RE: MOOLARBEN OC3 EXTENSION PROJECT – RESPONSE TO CPHR AND NPWS RECOMMENDATIONS

**RESPONSE TO CPHR/NPWS RECOMMENDATIONS
(ATTACHMENT A OF CPHR/NPWS ADVICE LETTER)**

Figure 1: Conceptual Hydrogeological Cross-section Locations (Source: AGE, 2025)

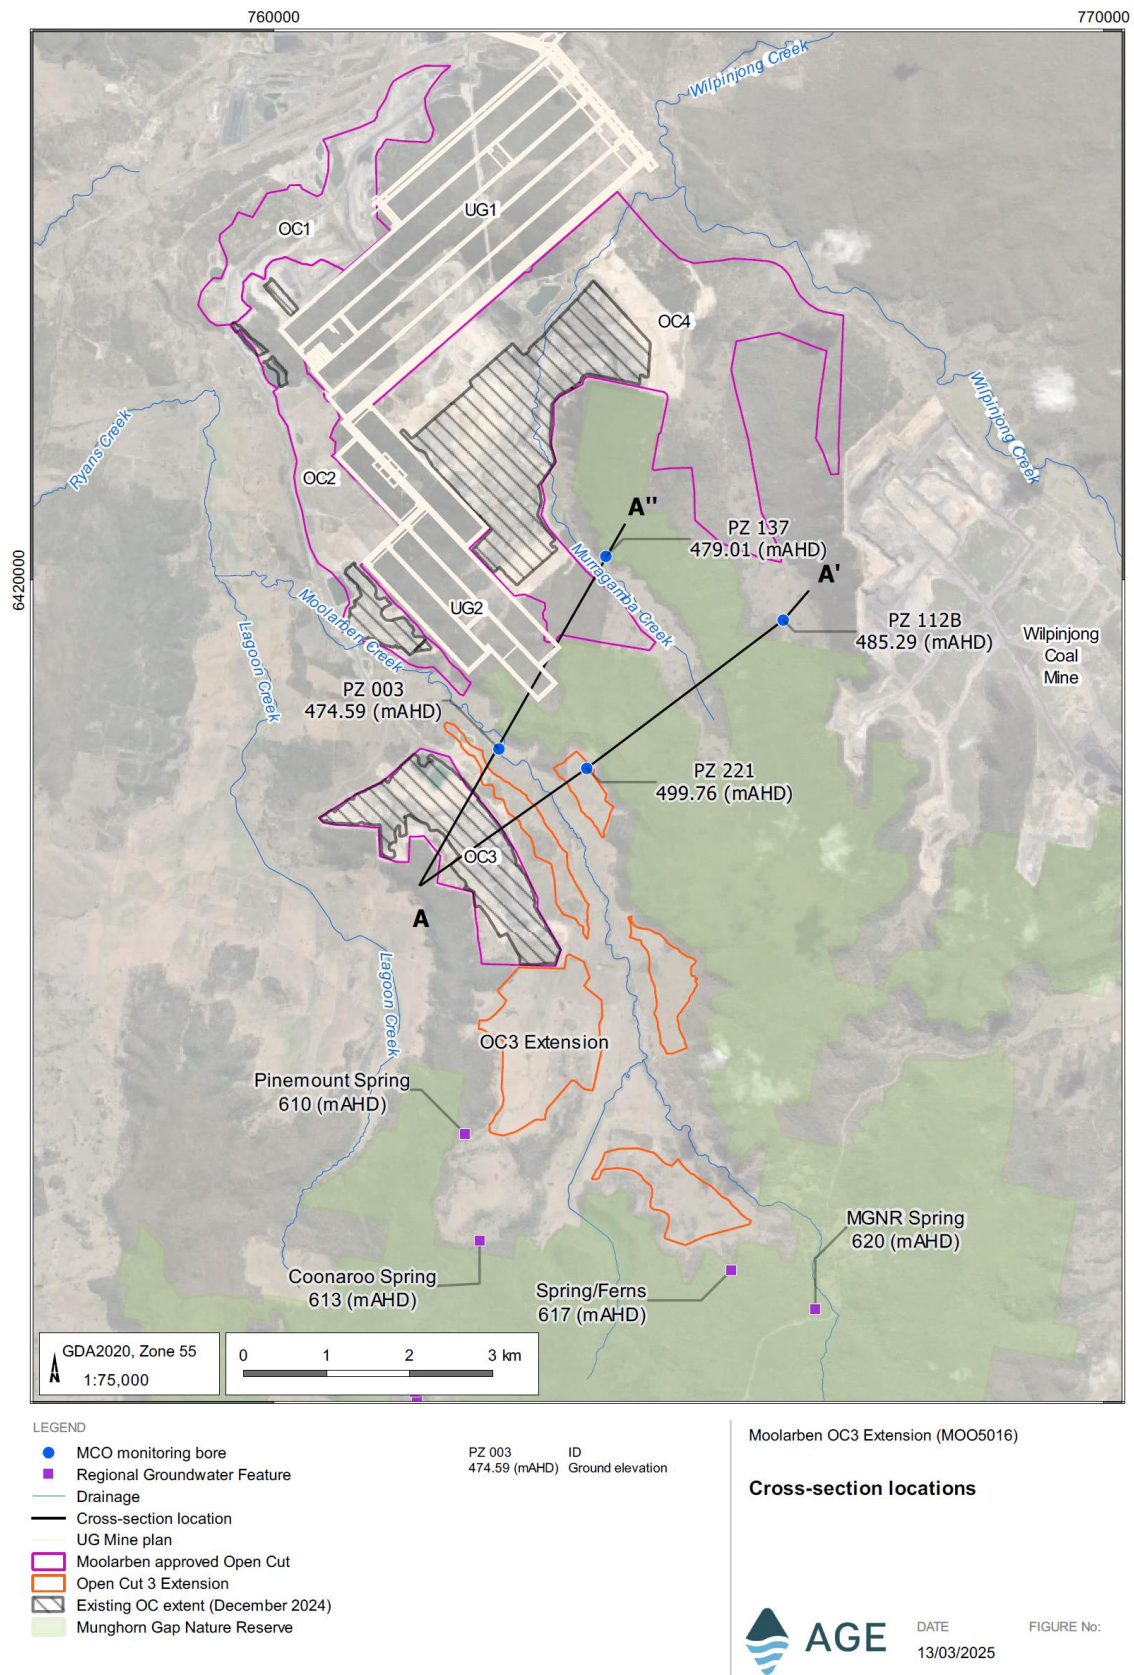
17.1a	<i>Revise the project to reduce the impacts on groundwater dependent ecosystems, springs and creeks within the development footprint and Munghorn Gap Nature Reserve. Alternatively, provide mitigation measures to address these impacts.</i>	Given the limited extent of predicted impacts, it is not feasible or reasonable to revise the Project to further ‘reduce impacts’ to potential terrestrial groundwater dependent ecosystems (GDEs), spring/seep features and/or creeks within the disturbance extent or the Munghorn Gap Nature Reserve. 1. Within Development Footprint MCO would offset impacts to potential terrestrial GDEs within the Project disturbance extent as ecosystem credits for associated PCTs in accordance with the BAM. The Project has already avoided major drainage lines within the Moolarben Valley via setback of open cut mining by at least 200 m from the high bank of Moolarben and Murdering Creeks. 2. Outside Development Footprint Less than 2 m drawdown is predicted at the mapped location of the majority of potential terrestrial GDEs within the Project area (but outside the disturbance extent). Approximately 6 ha of potential terrestrial GDEs are predicted to experience between 2 m and 6 m of drawdown. These potential terrestrial GDEs are wholly within Moolarben-owned land (i.e. not associated with the Munghorn Gap Nature Reserve). At the location of maximum drawdown (i.e. 6 m) the modelled baseline groundwater level is already approximately 10 m below the surface.

No.	Recommendation	Response
		The majority of potential terrestrial GDEs predicted to experience greater than 2 m drawdown are located within the Project Habitat Enhancement Area, which would be subject to ongoing enhancement and management measures. In the absence of the Project, these areas would have no formal biodiversity protection or management. MCO would accept an approval condition to monitor and manage areas of potential terrestrial GDEs outside the disturbance extent and within the Project area. The Project would not result in a long-term reduction in water availability for terrestrial vegetation along Moolarben Creek and associated low-lying areas, as mining areas would be rapidly backfilled to restore pre-mining hydraulic gradients and allow water levels to recover. Given the 200 m buffer between open cut mining and both sides of Moolarben Creek (and Murdering Creek), natural surface water flows would not be disrupted during operations. 3. Within Munghorn Gap Nature Reserve The Project is highly unlikely to impact water-dependent assets (i.e. perched features) in the Munghorn Gap Nature Reserve. As the regional groundwater table (i.e. within the Permian strata and principally within the coal seams) is inferred to be up to 100 m below the surface of the Munghorn Gap Nature Reserve, the perched features are not likely to be connected to the regional groundwater system. Conceptual cross-sections at the locations shown on Figure 1 are provided on Figure 2 and 3. These cross-sections intersect the existing OC3 open cut pit, proposed OC3 Extension pits and the Munghorn Gap Nature Reserve. AGE has considered groundwater data from monitoring bores within the Moolarben Valley (i.e. PZ003 and PZ221) as well as east of the Project (i.e. PZ137 and PZ112B) which indicates that the regional groundwater level within the permian overburden is up to 100 m below the surface of the Munghorn Gap Nature Reserve (Figures 2 and 3). Figure 1 also demonstrates the surface elevation at the closest spring and seep features in the southern extent of the Project area, which are greater than 100 m above the surface elevation at the monitoring bores. There is no drawdown predicted at the closest spring and seep features.
